AMENDMENTS TO THE DRAWINGS

REMARKS

This amendment is responsive to the Office Action dated October 20, 2008. Claim 1 is currently amended. New claim 3 has been added. Support for these amendments may be found variously throughout the Specification, for example on page 9, lines 26 – page 12, line 13. *These amendments add no new matter.* In the amendment, claim 1 remain pending in the application. Reconsideration and allowance of the pending claims are respectfully requested.

Fig.1

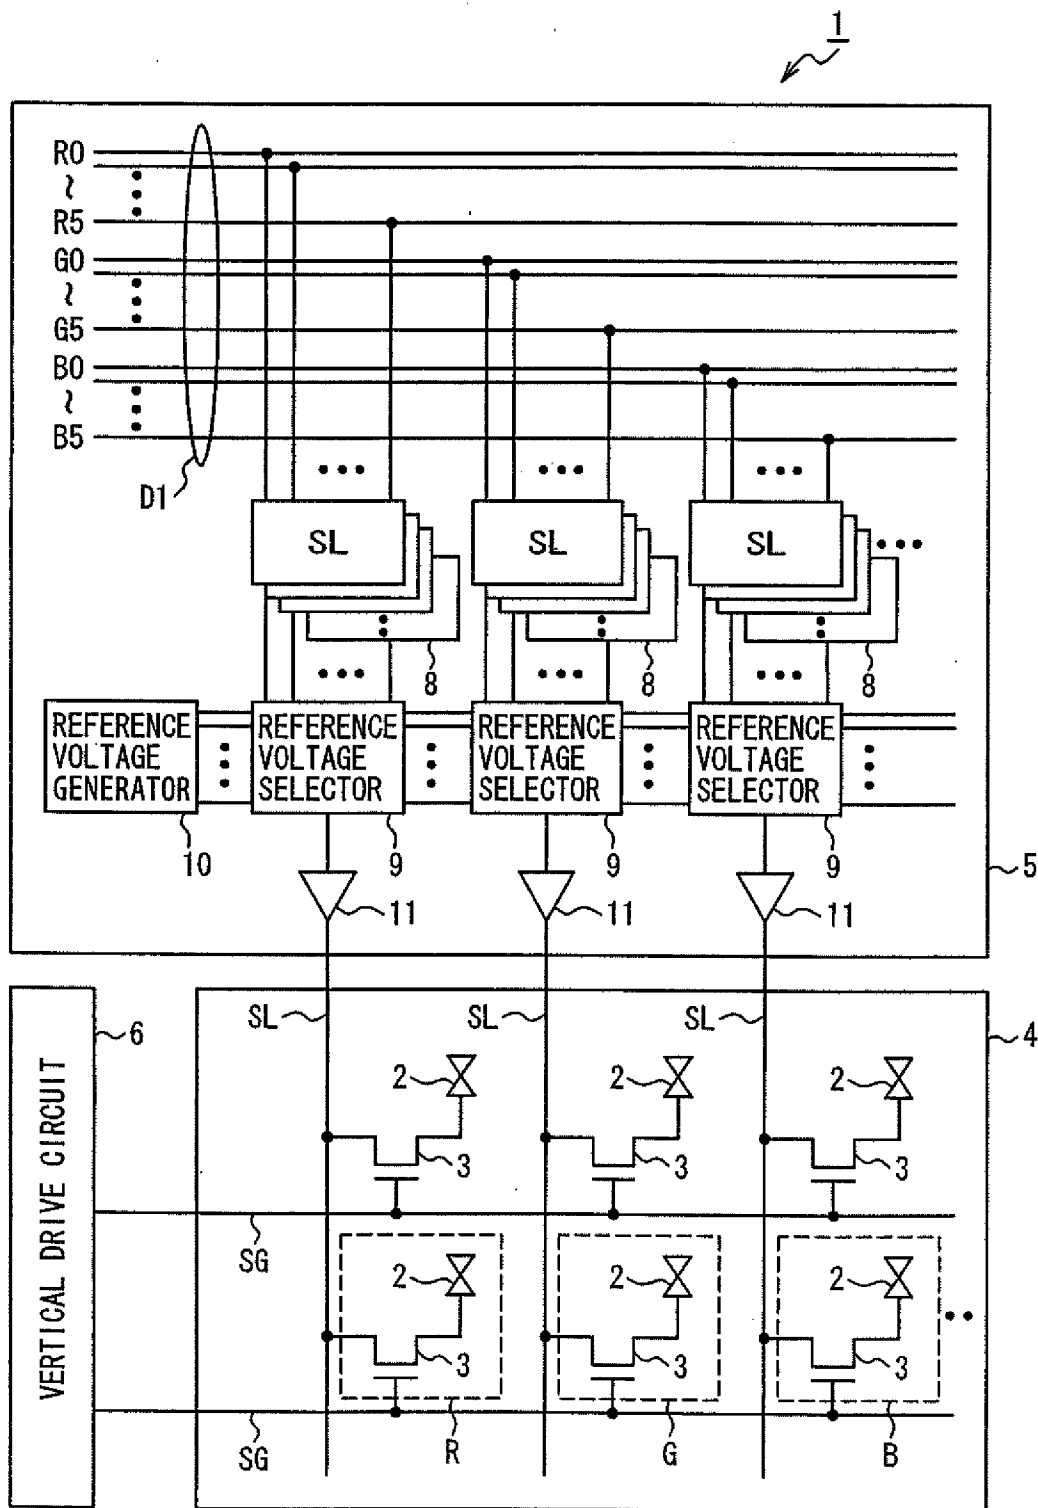
The attached sheets of drawings include changes to FIGS. 1, 2, and 3 labeling FIG. 1, FIG. 2, and FIG. 3 as --BACKGROUND ART-- as described in the pages 1-6 of the Specification. Additionally, reference characters "Lout_(Inv)" and "Lout_(Non-inv)" have been added to distinguish the inverted and non-inverted Lout as shown in FIGS. 2, 3, and 4, as described in page 5, line 21 – page 6, line 17 and page 11, line 24 – page 12, line 11. Also, "VSS~HVSS2" has been deleted from FIG. 4.

--BACKGROUND ART--

Fig.3
-- BACKGROUND ART --

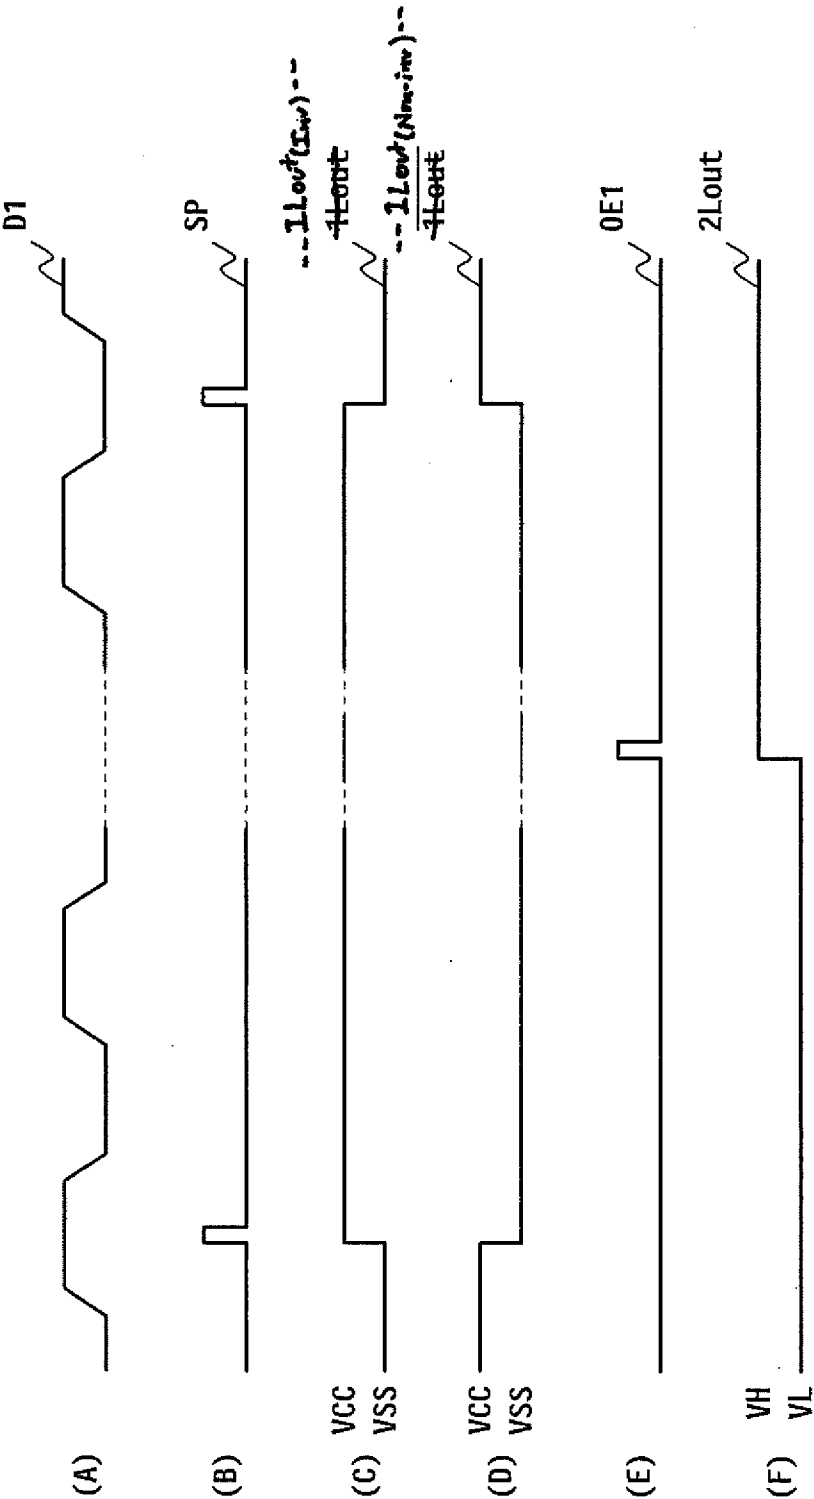
Additionally, while FIG. 3(C) and 3(D) discloses the inverted and non-inverted output voltages 1Lout_(Inv) and 1Lout_(Non-inv) rising and falling with timing SP, AAPA clearly fails to disclose or suggest “*raising a power supply voltage of said first latch section from a first voltage to a second voltage while said first latch result is transferred to said second latch section[.]*”
